STREET ADDRESS
2801 FRANKLIN ROAD S.W.

REV	DATE	DESCRIPTION	BY	ISSUED
1	08/21/05	PERMIT REVIEW COMMENTS	JAL

C3
SITE UTILITY PLAN

2 / C3 EXTERIOR GREASE INTERCEPTOR DETAIL ⚠1
SCALE: N.T.S.

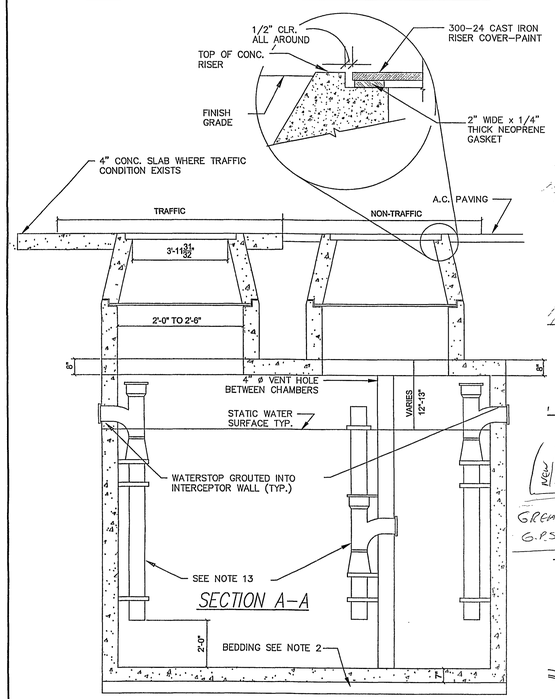
14. NEW GAS METER & SERVICE PRESSURE REGULATOR. G.C. TO COORDINATE PLACEMENT WITH MIKE CHRISTIAN AT ROANOKE GAS (Tel.#: 540-777-3970)
15. EXTERIOR 1000 GALLON GREASE INTERCEPTOR. COORDINATE WITH McDONALDS PROJECT MANAGER AND REFER TO SHEET P3 OF THE ARCHITECTURAL DRAWINGS. ALSO REFER TO DETAIL 2 THIS SHEET FOR EXTERIOR GREASE INTERCEPTOR DETAIL. VERIFY FINAL LOCATION WITH McDONALDS PROJECT MANAGER. ⚠1

3 / C3 SAMPLING STRUCTURE DETAIL ⚠1
SCALE: N.T.S.

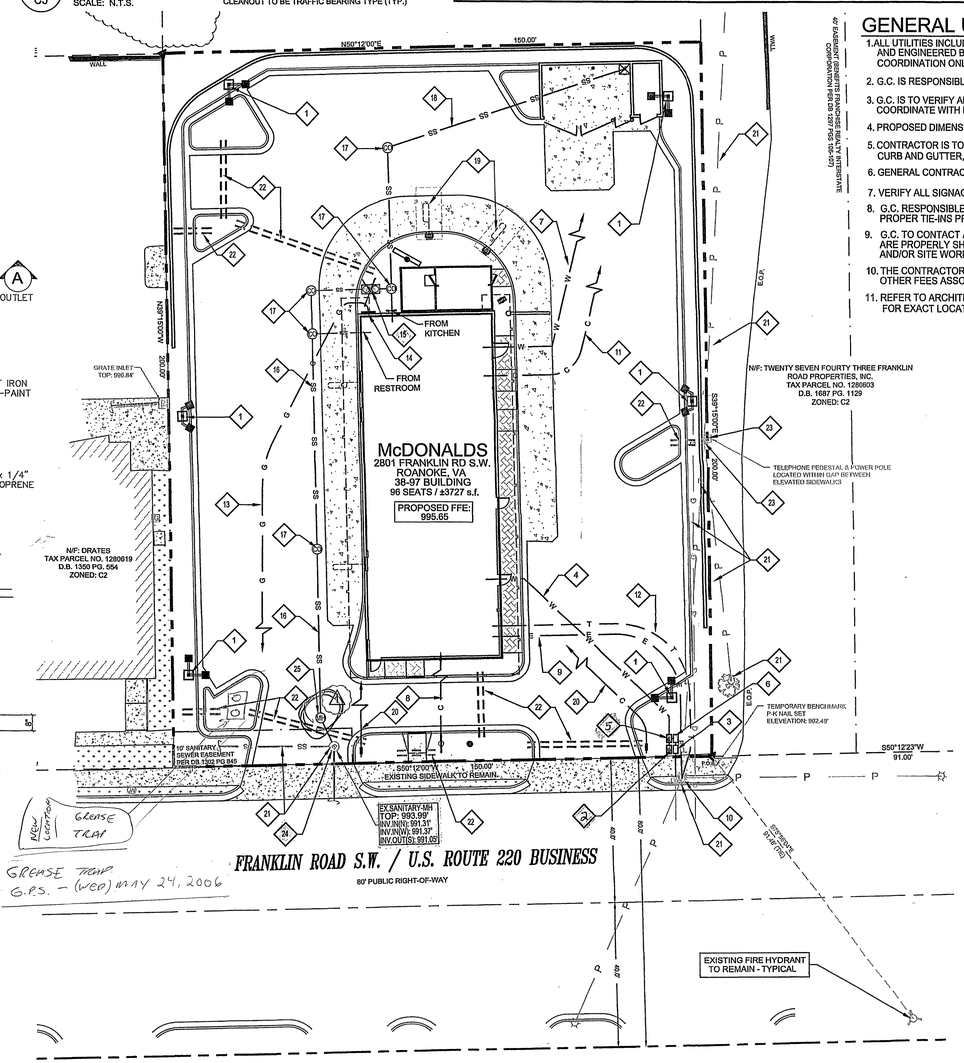
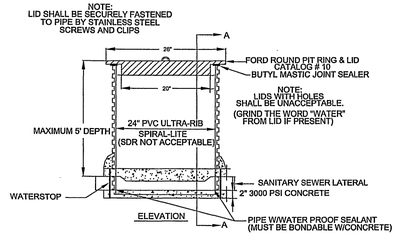
25. SAMPLING MANHOLE ON PRIVATE SANITARY SEWER LINE. COORDINATE WITH JAMIE MORRIS WITH WVWA (540-853-1588) AND REFER TO DETAIL 3, THIS SHEET. ⚠1
